- 4. CASE 21.009, 59 PARADE STREET, House, c1870 (ARMORY)
2½-story; end-gable; shingle typical double house; with eave returns and full 2-story porch.
CONTRIBUTING

Project: Two Family Residence
Address: 59 Parade Street, Providence, RI 02909
Date: 5 February 2021
Re: Application Information

PROPOSED WINDOW SASH REPLACEMENT
TWO-FAMILY BUILDING
 59 PARADE STREET
 PROVIDENCE, RHODE ISLAND 02909

WINDOW ELEVATIONS

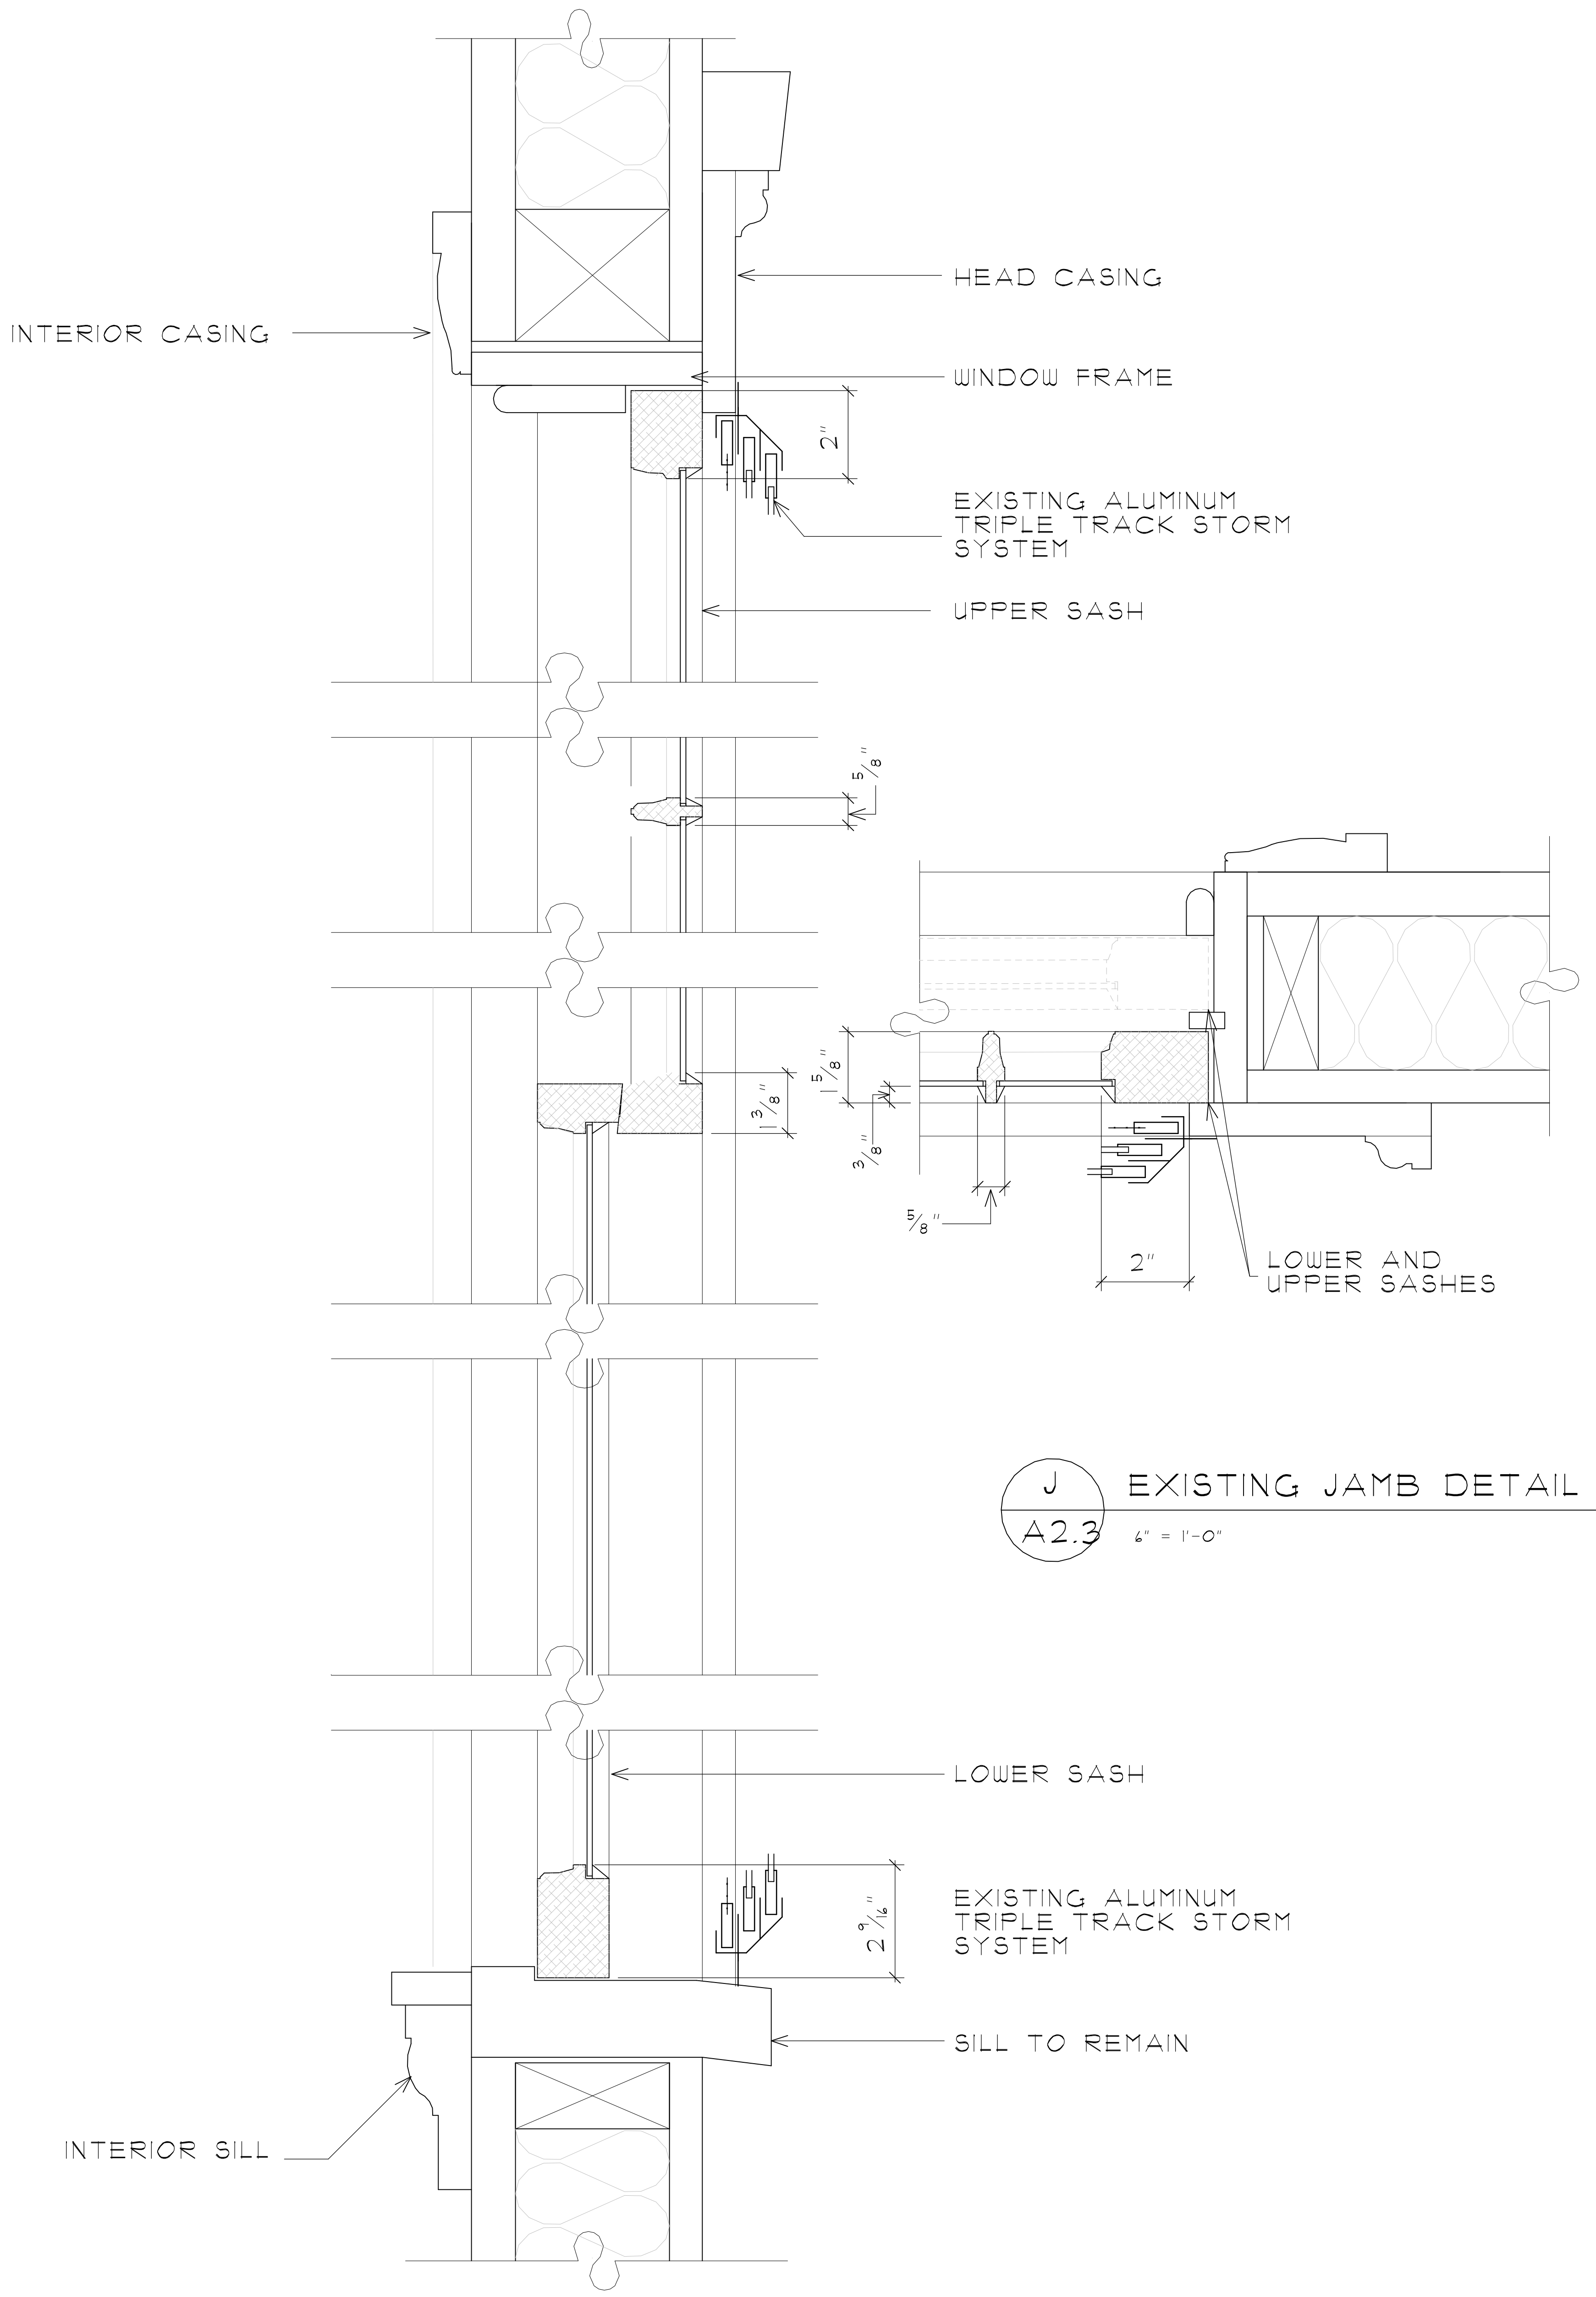
- There are 31 windows in the house, 28 are proposed to be replaced. Of the 28 windows to be replaced, 13 are original. The proposed replacement units are the Trimline Ultra Fit (Classic Clad) sash replacement kits;
- The property is a multi-family and as such requires a lead-safe certificate. The proposed work allows the property to come into compliance with RIGL § 42-128.1-8; and,
- An architect's narrative, plans and photos have been submitted.

- Aesthetics – The Owner is willing to install replacement window sashes which are nearly identical to the existing. The muntin size and spacing will be matched. The difference in glass area reduction is 2.44%. From the exterior, the new sashes, along with removal of the storm windows, will result in windows which are close to the original in size, function, appearance and profile depth with windows within the wall plane, which is diminished by the storm windows.
- Lead Safety – The removal of the existing painted wood sashes, combined with the new sash operation with greatly reduce lead exposure within the building.

- a) 59 Parade Street is a structure of historical and architectural significance that contributes to the significance of the Armory local historic district, having been recognized as a contributing structure to the Broadway/Armory National Historic Register District;
- b) The application for Major Alterations is considered complete; and,
- c) The work as proposed is in accord with PHDC Standard 8 as follows: as the proposed alterations are appropriate having determined that the proposed construction is architecturally and historically compatible with the property and district having an appropriate size, scale and form that while diminishing the historic quality of the property will not have an adverse effect on the property or district and allows the property to come into compliance with RIGL § 42-128.1-8.
